## ADDENDUM #9

**Western Slope Food Bank of the Rockies**  
698 Long Acre Drive

**Bid Package #4 – Above Ground**

Architect's Project No. 2108

**KITCHEN - FOODSERVICE EQUIPMENT PLAN**  
SCALE: 1/4" = 1'-0"

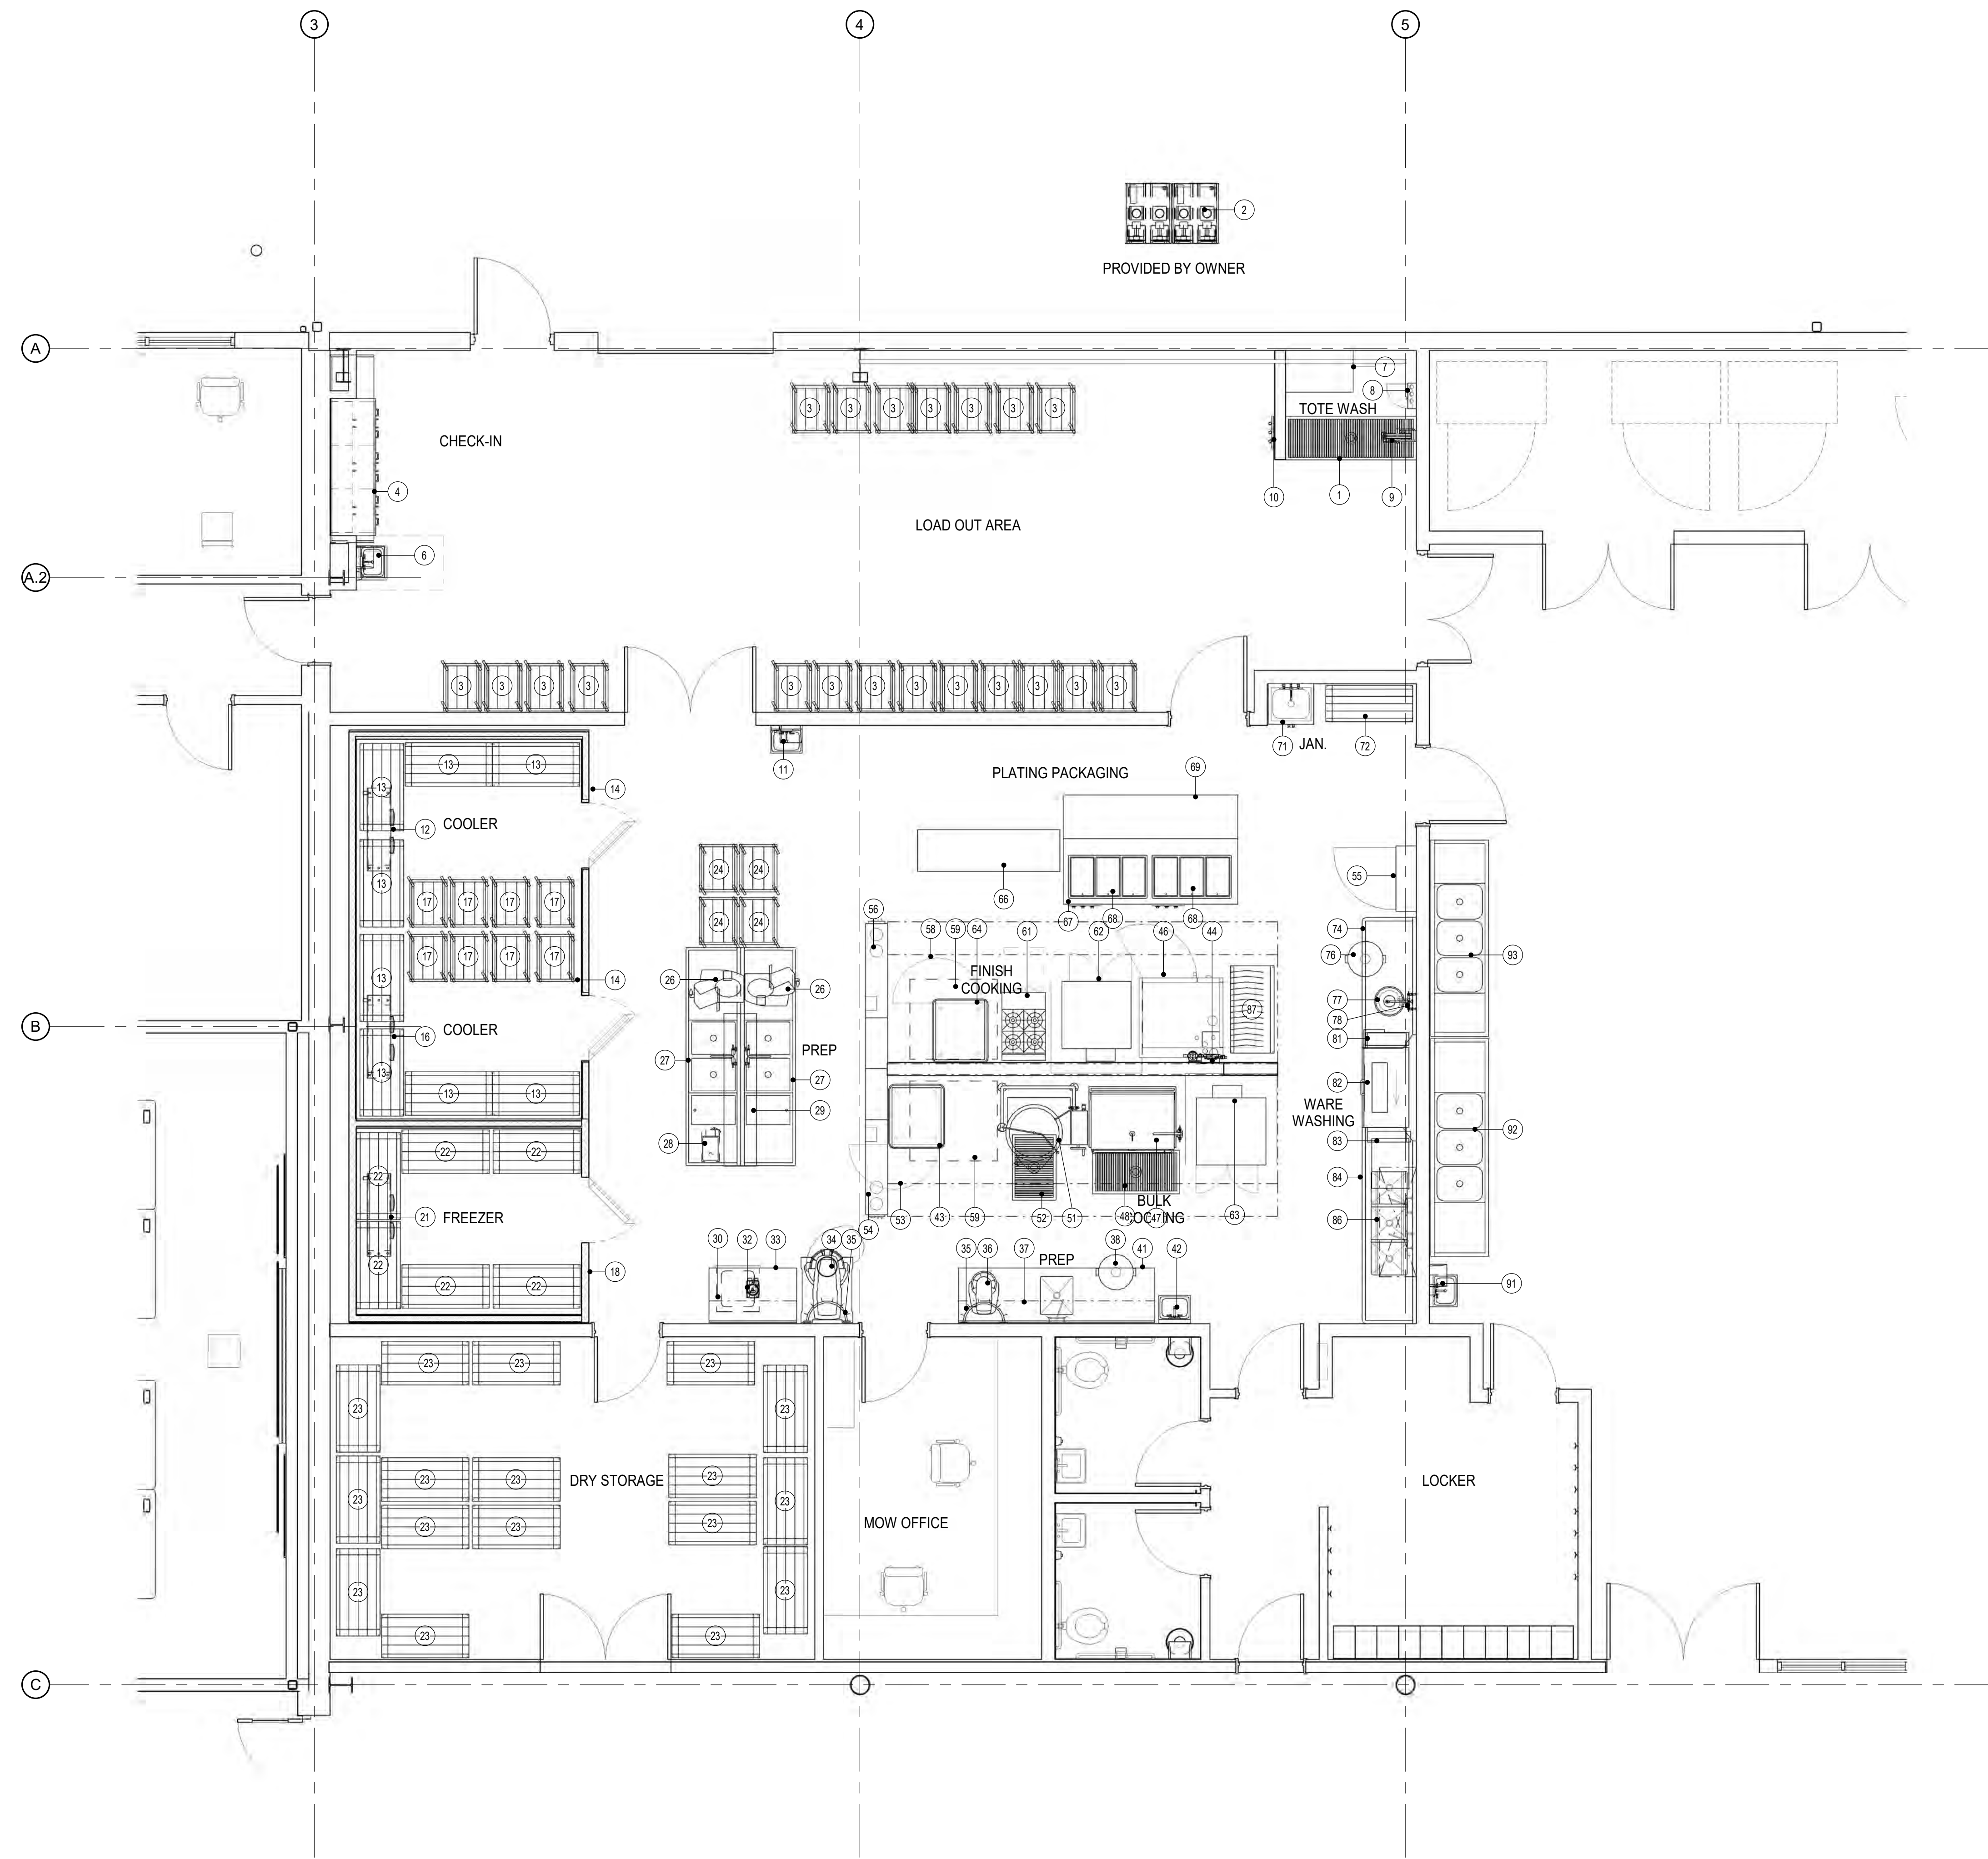
EQUIPMENT NOTED BELOW AS "GC" SHALL BE PROVIDED (FURNISHED AND INSTALLED) IN THIS CONTRACT. ALL OTHER EQUIPMENT LISTED ON THIS SHEET WILL BE UNDER SEPARATE CONTRACT AND IS LISTED FOR REFERENCE AND COORDINATION PURPOSES ONLY. MECHANICAL, PLUMBING, AND ELECTRICAL ROUGH-IN AND WALL BLOCKING FOR ALL EQUIPMENT SHALL BE PROVIDED UNDER THIS CONTRACT. REFER TO SPECIFICATION SECTION 114000 FOODSERVICE EQUIPMENT FOR ADDITIONAL INFORMATION AND REQUIREMENTS RELEVANT TO THE WORK WITHIN THE SCOPE OF THIS CONTRACT.

ADD #9

**KITCHEN - BUILDING CONDITION & VENTILATION PLAN**  
SCALE: 1/4" = 1'-0"

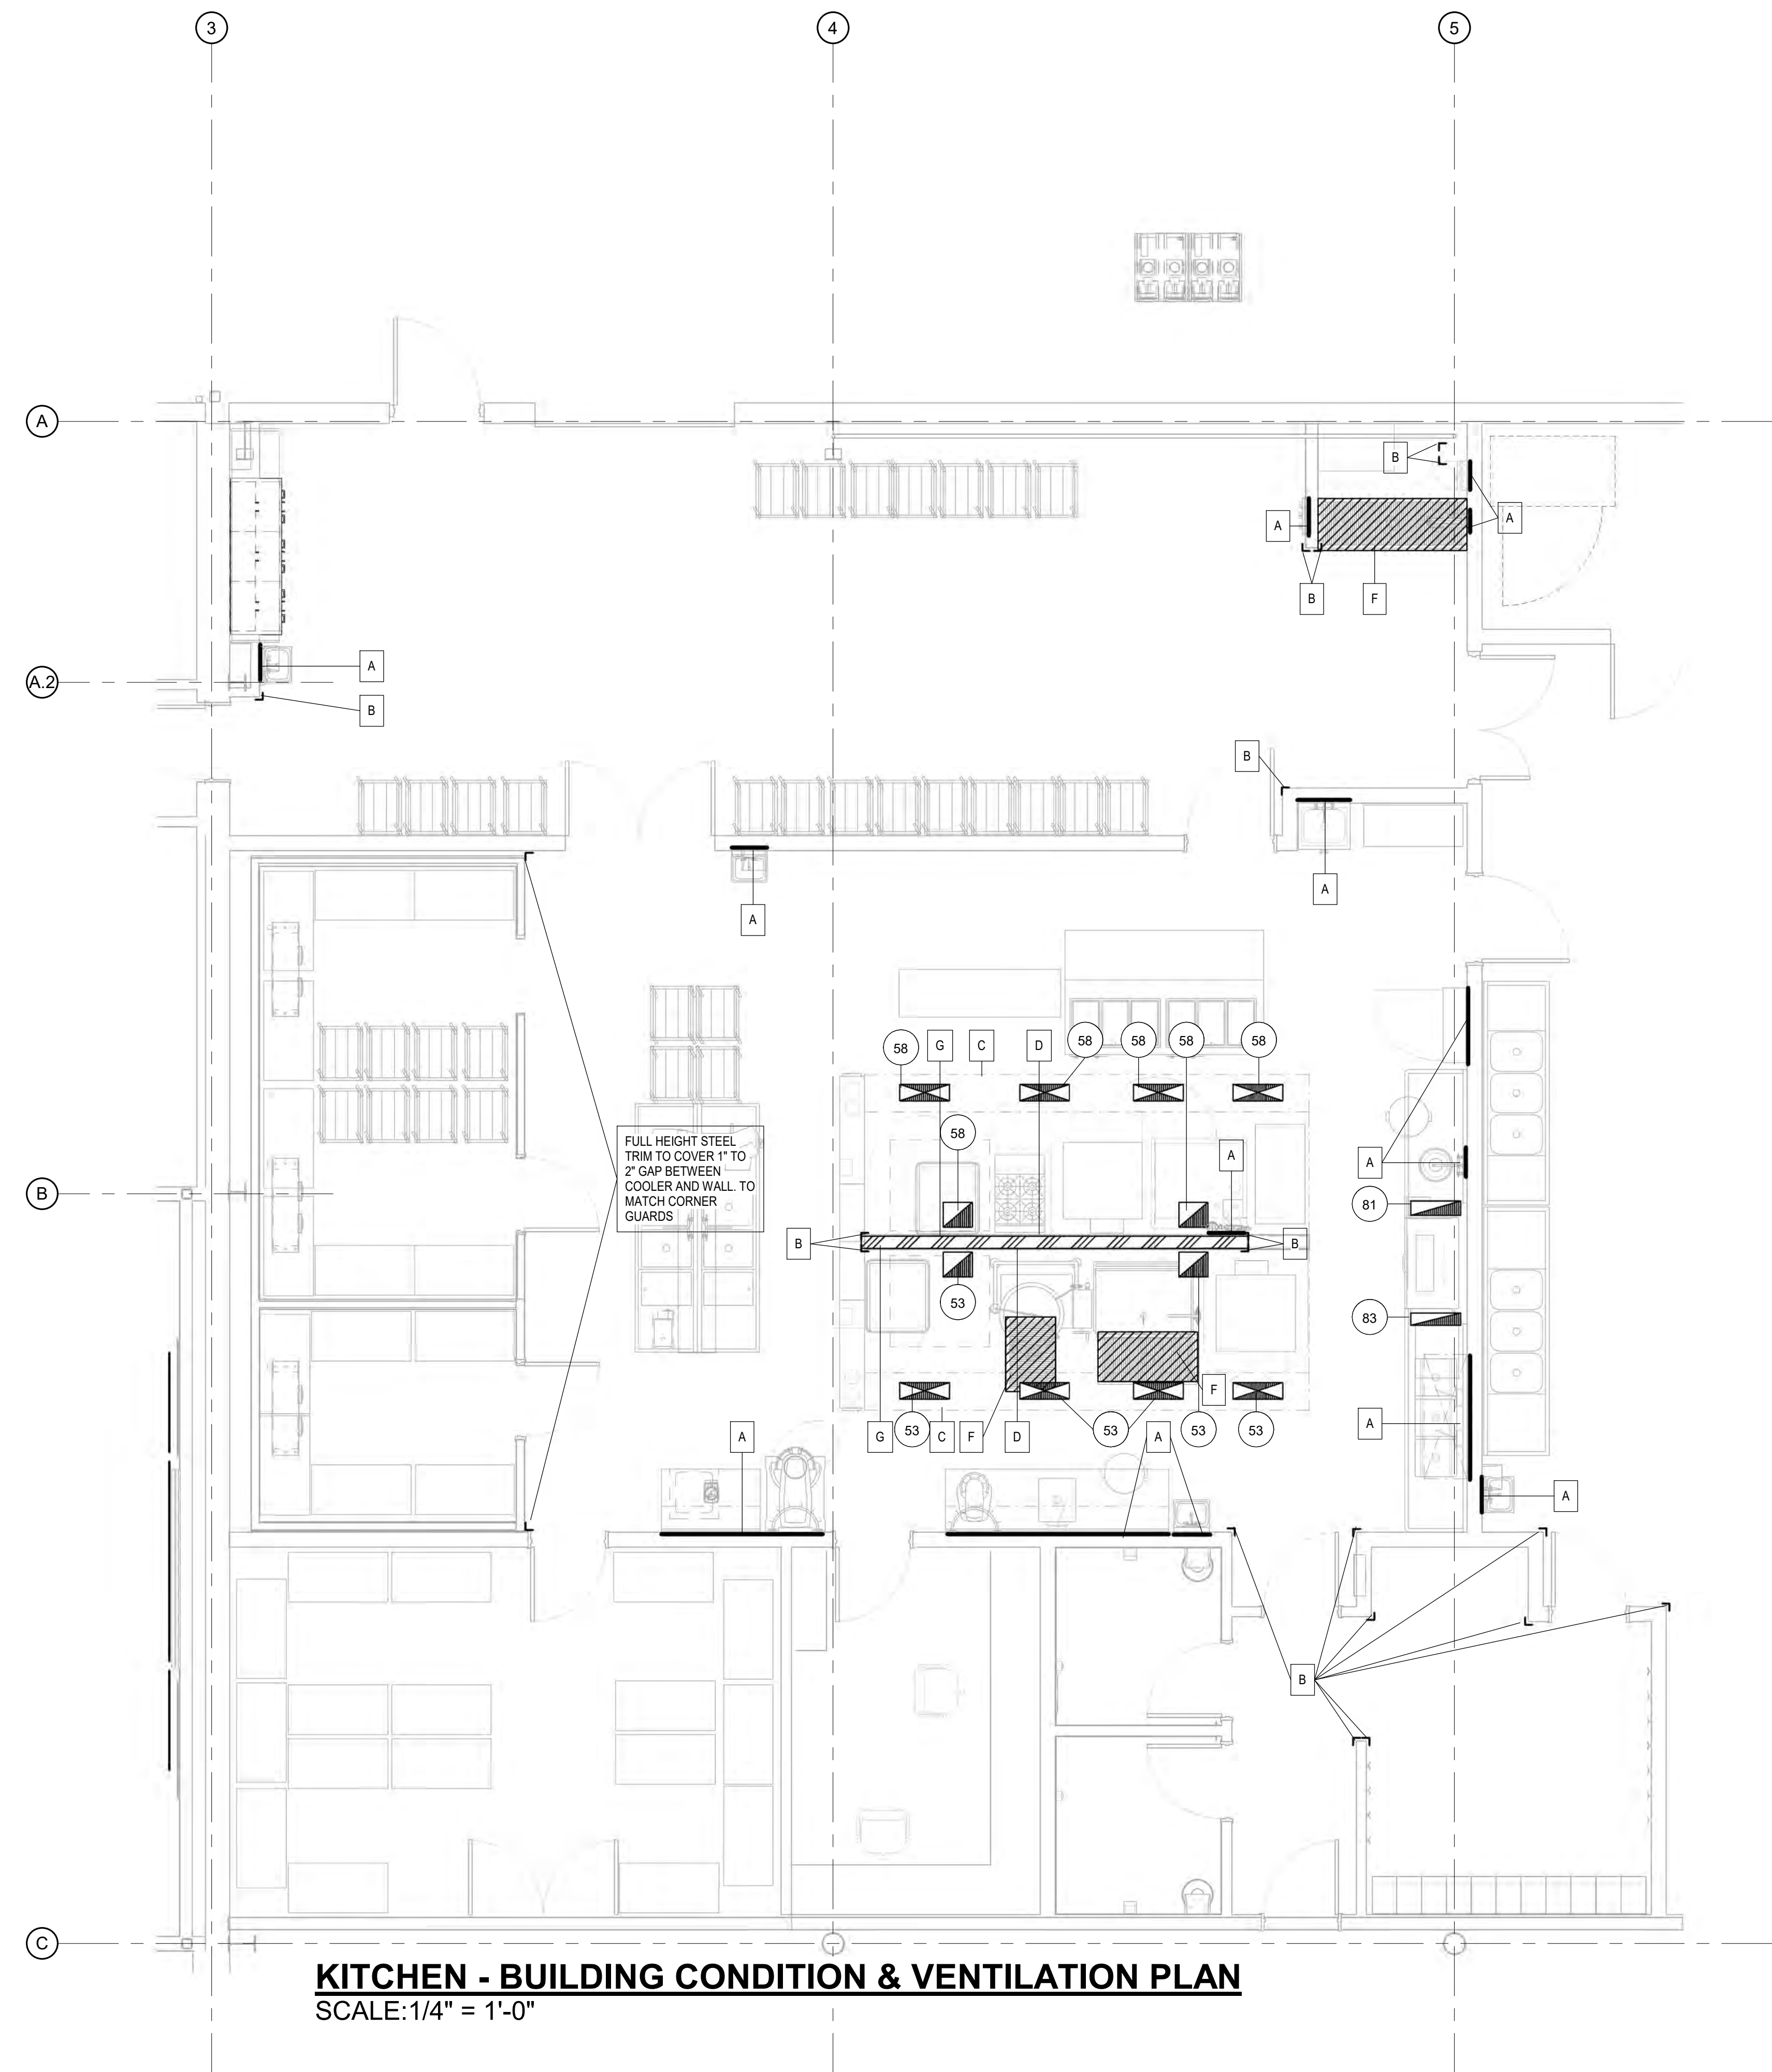
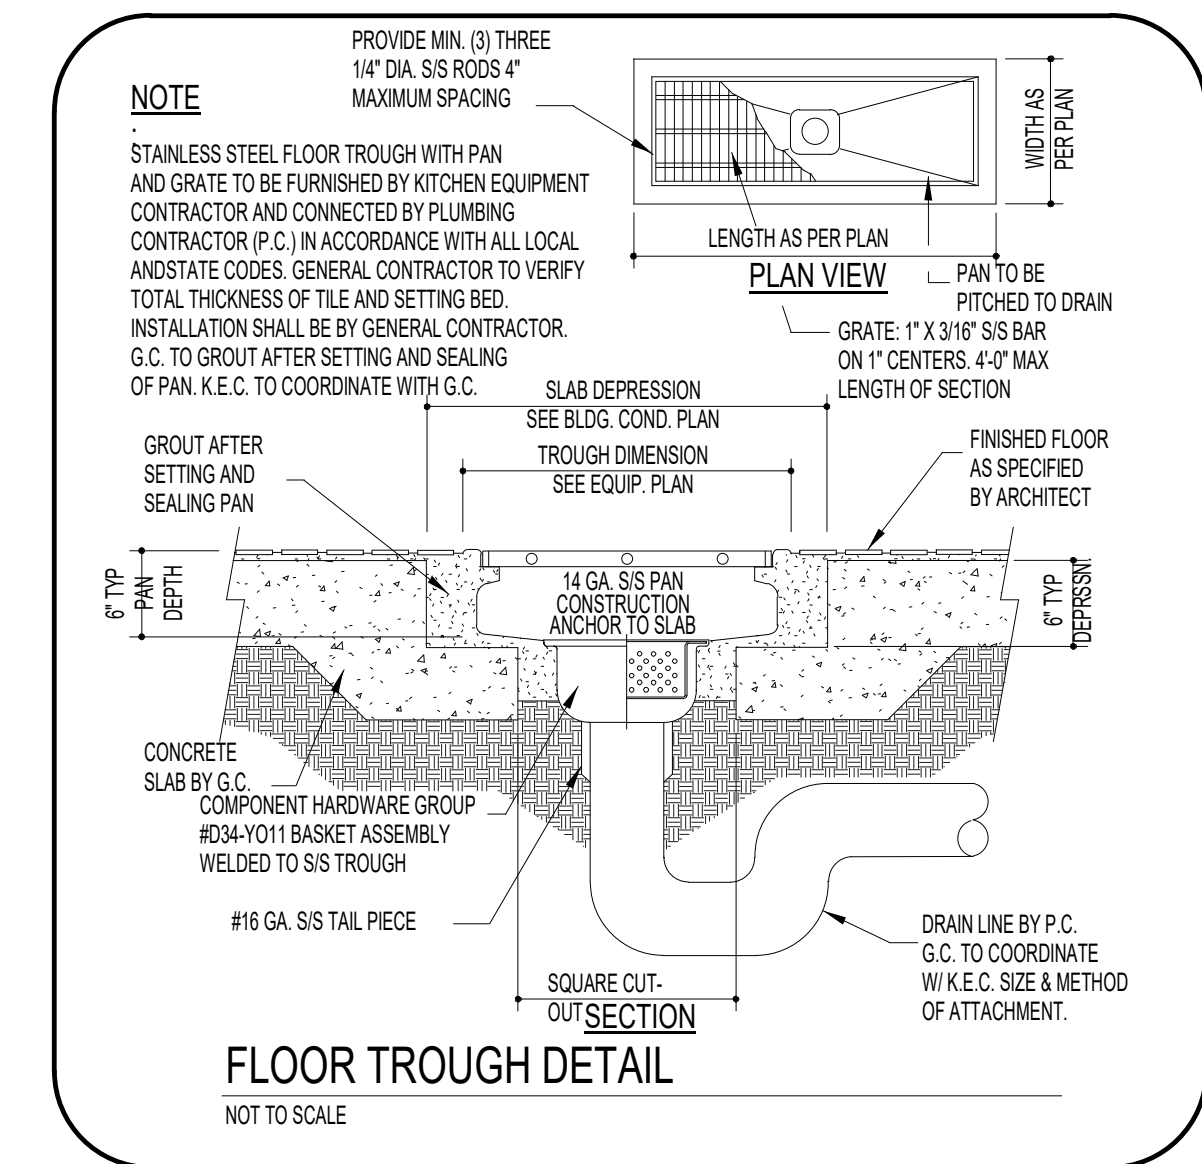
ADD #9  
ALL WORK SHOWN ON THIS SHEET SHALL BE PROVIDED IN THIS CONTRACT, INCLUDING MECHANICAL, PLUMBING, AND ELECTRICAL ROUGH-IN, WALL BLOCKING, AND CORNER GUARDS AND TRIM AS SHOWN.
